## **ZONING CHANGE REVIEW SHEET**

**CASE:** C14T-03-0001.01

**ADDRESS:** Dessau Road

In this application, the applicant is requesting to amend the approved Pioneer Hill Traditional Neighborhood District (TND) to ask for 10 additional variances to the TND requirements in the City of Austin Land Development Code (Please see Requested Variance List - Attachment B). The applicant is seeking to modify the TND ordinance and land use plan to alter the mix of housing types within the TND, to remove the requirement for a square within the Neighborhood Center Area (NCA), to remove the civic use area within the Mixed Residential Area 1(MRA1) that is currently designated for a Manor ISD school site, to amend the subdivision procedure requirement that states that, "a plat for no more than 50% of the land in the MRA1 may be approved until construction of the community center has started", to alter the TND requirement that every lot in the MRA1 should abut an alley to state that, "Only lots fronting the main boulevard are required to have alley access.", to relocate the community meeting hall within the MRA1 portion of the TND, to delete the open space requirement for a one acre square in a TN

# Parkland Purchase Option Property of HOA Open Space Area 2 0.14 Ac.

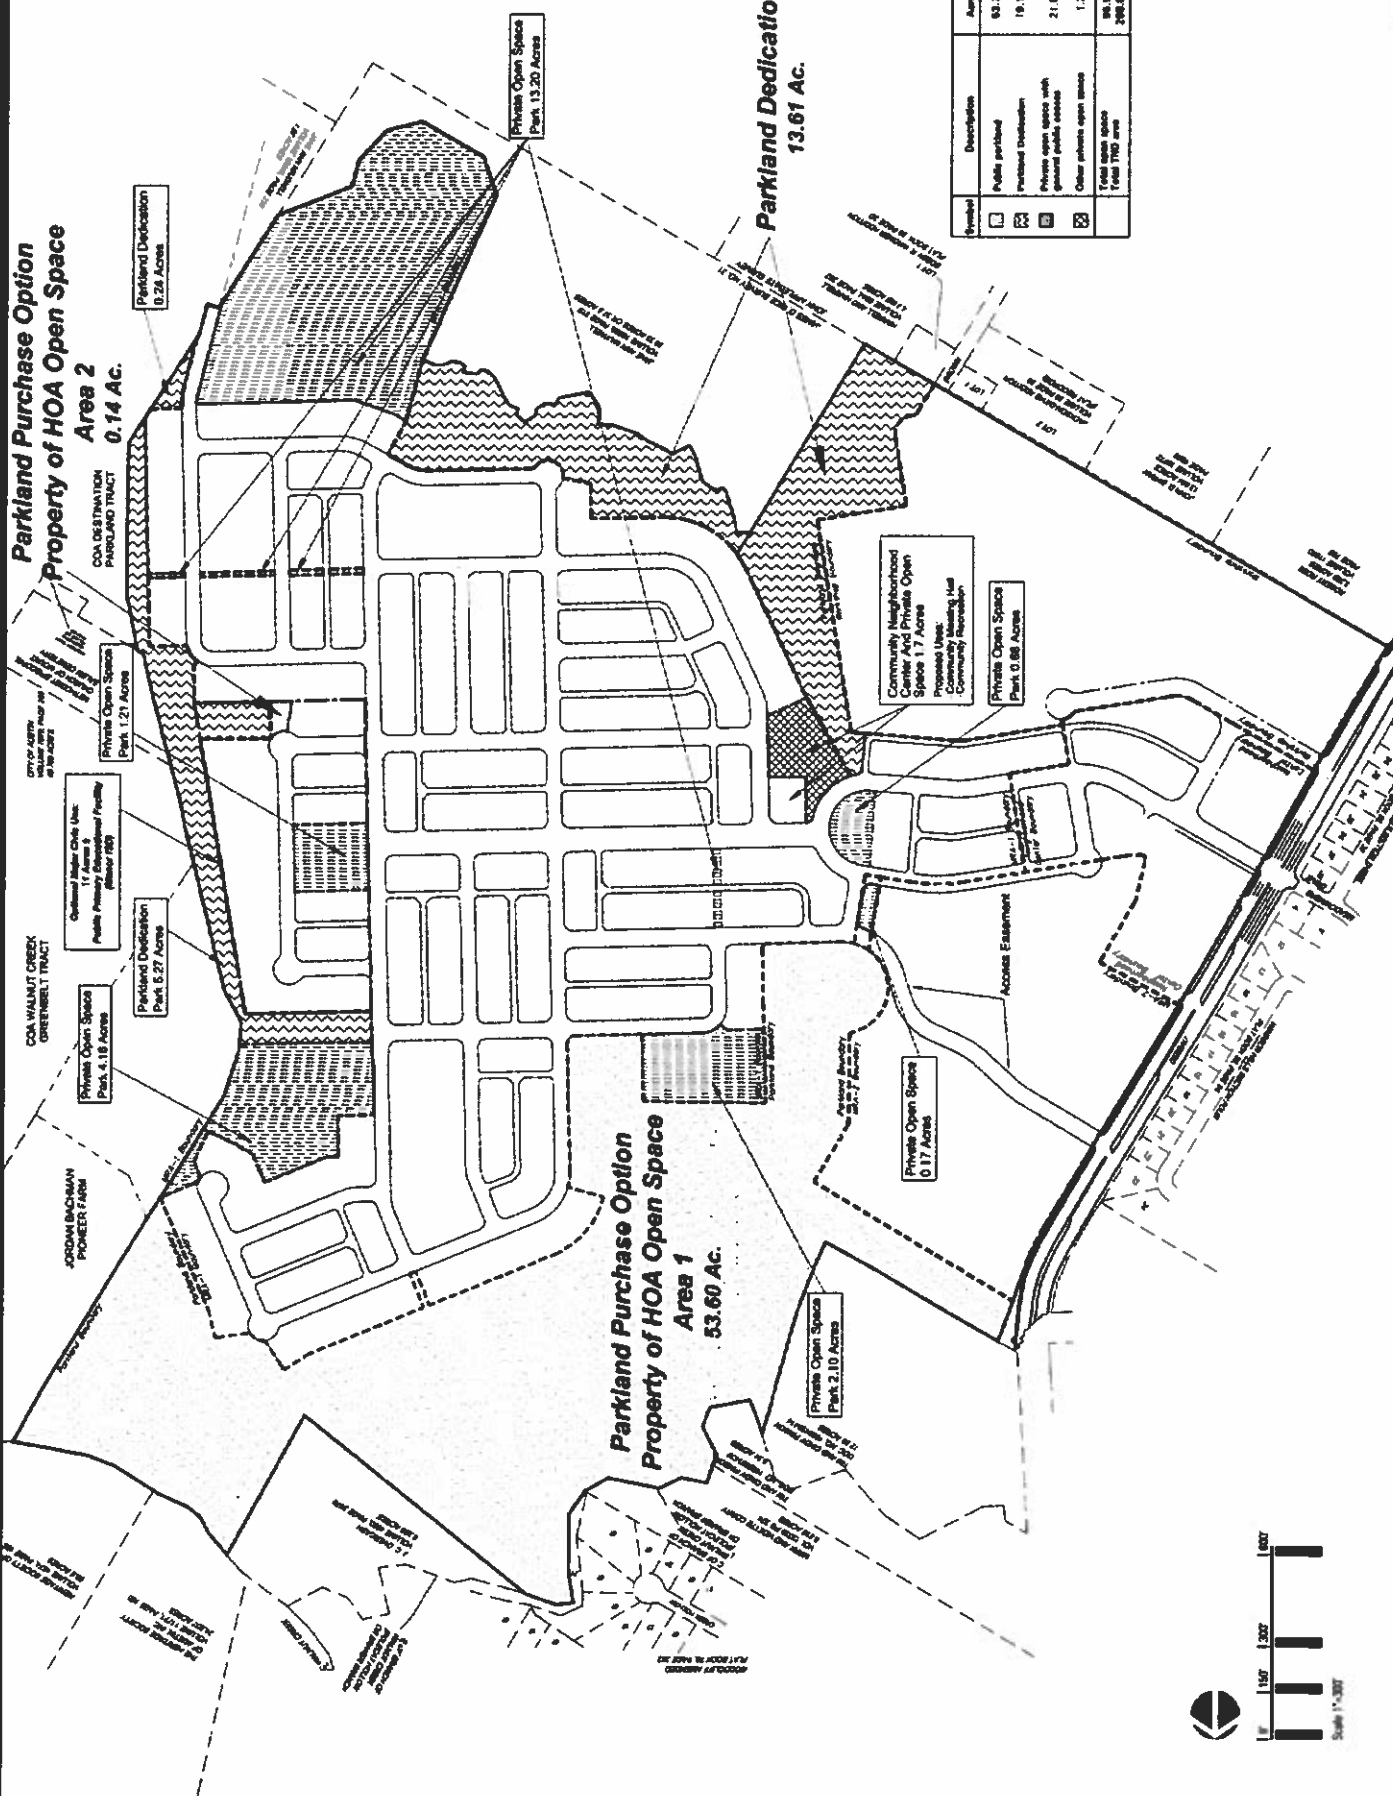
In addition, the staff recommends the alterations proposed by the Parks and Recreation Department in response to the applicant's request to delete the open space requirement for a one acre square in a TND for 100 acres or more. These changes are shown on the revised land use plan (Please see Attachment B).

- e. The developer will give PARD a 5 year option to purchase part or all of the land indicated as "Public Open Space" on the land use plan. The land would be sold to the City at a rate not to exceed \$10,835 per acre.

4,000 ± sq. ft.  
Town Progression Plan

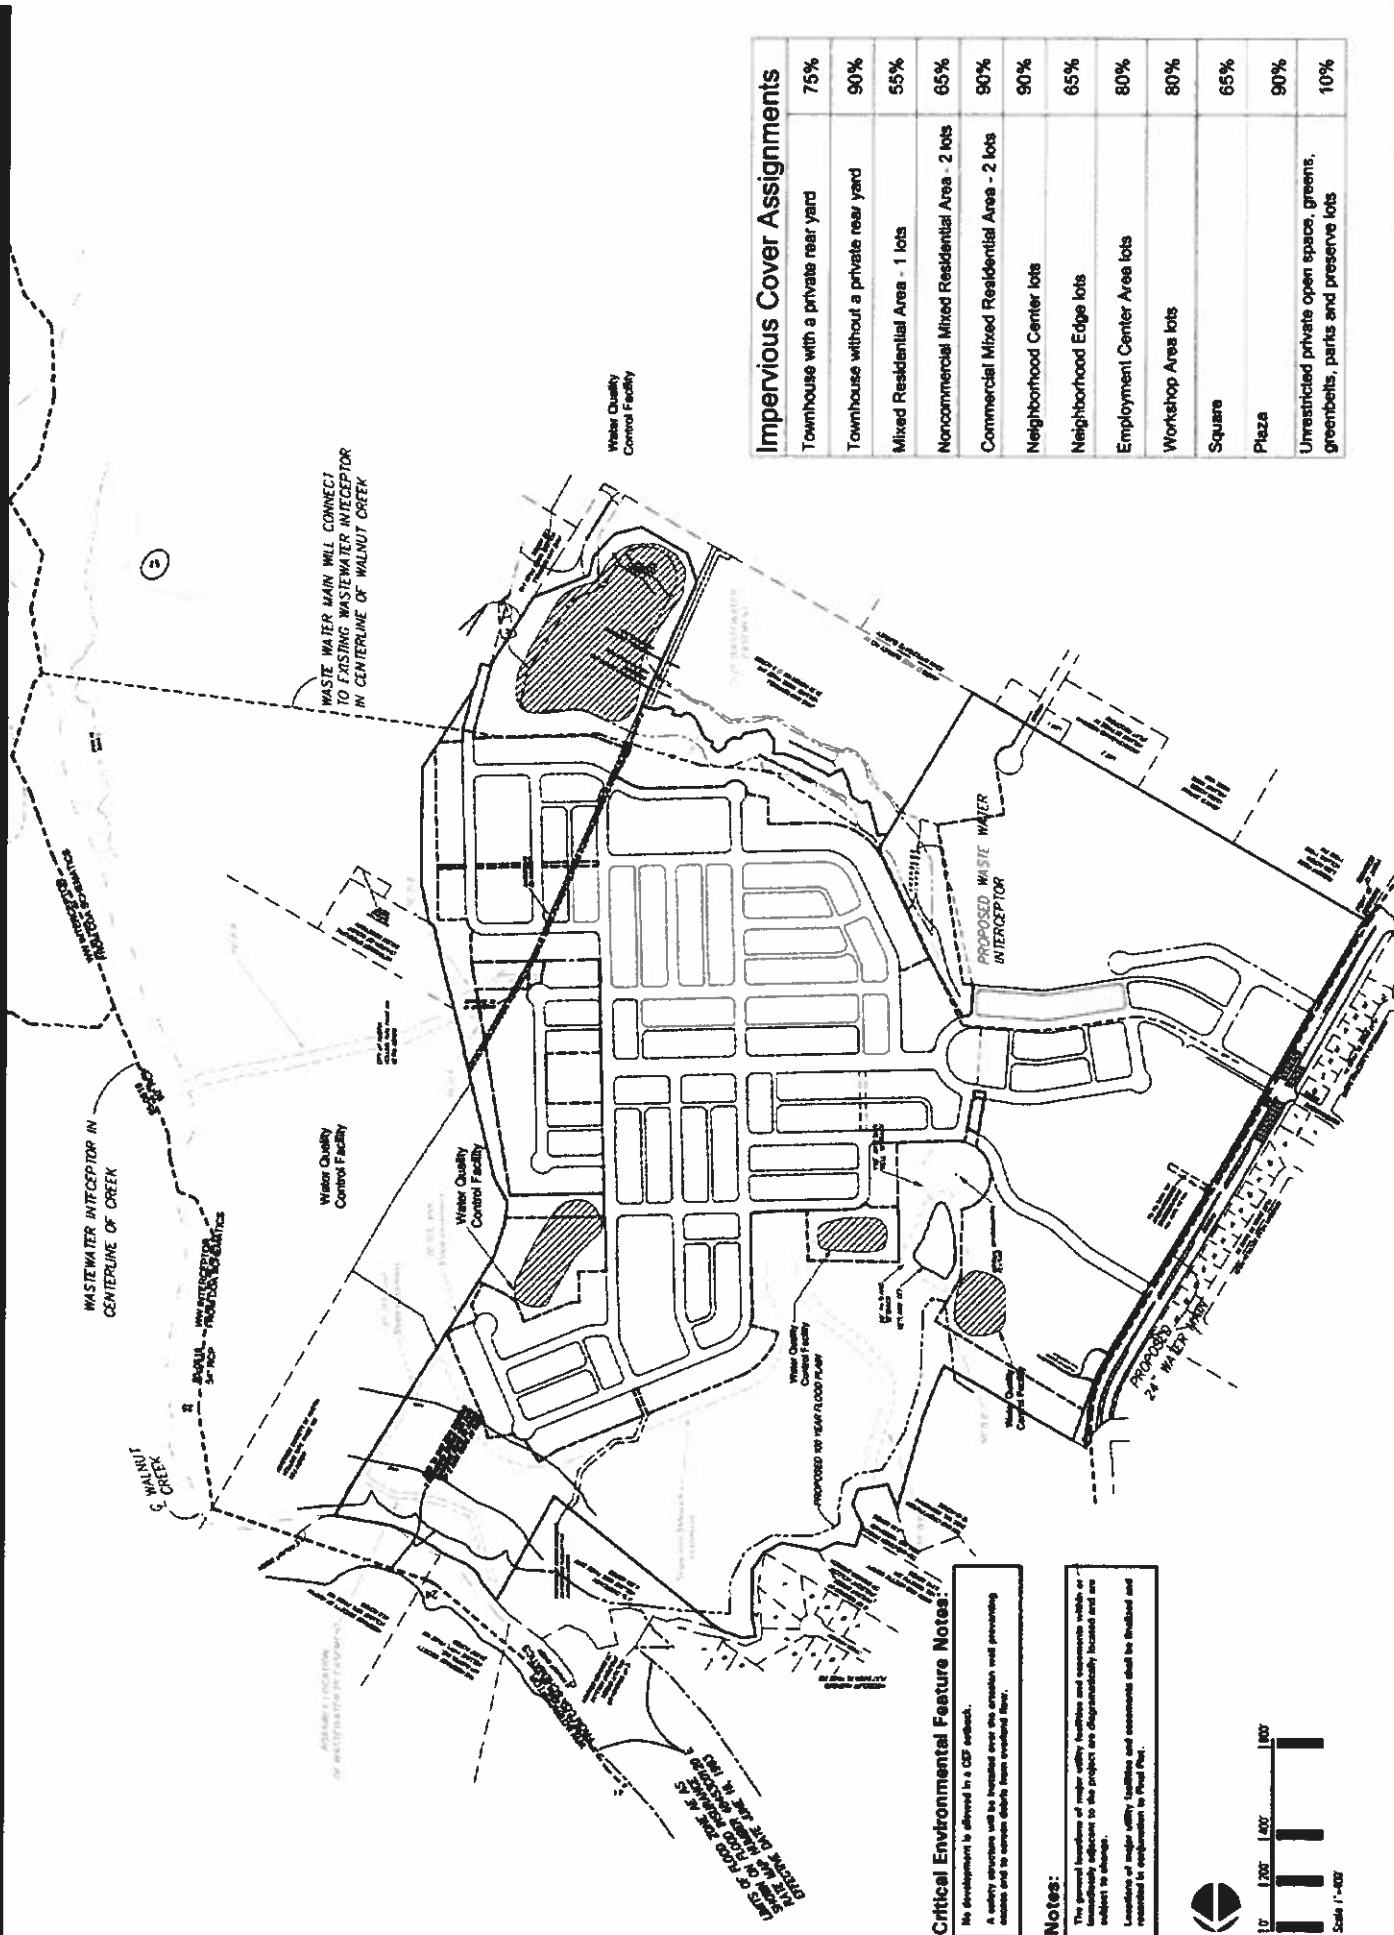
A site visit was conducted on February 28 by Andrew Clamann and Sylvia Pope. A water well and wetland were confirmed in the area identified in the original application on the Drainage Control and Environmental sheet. The water well has a 150-foot radius CEF setback and the wetland has a 50-foot radius CEF setback. We also identified a spring/seep down gradient of the wetland and within the area designated as a public park on the TND application. No further comments.
